## MESH2 Cancel Motor Cover

### Change Notification

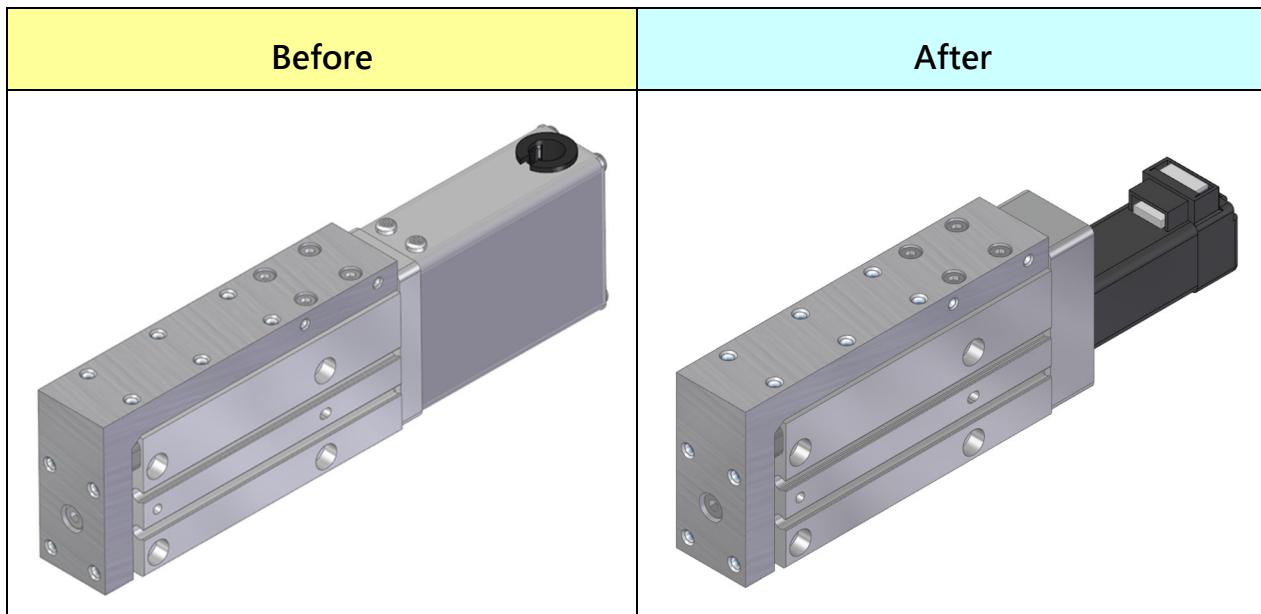
Cancel the motor cover.

#### 3. Change descriptions

It will not affect performance or usability, and will be replaced sequentially.
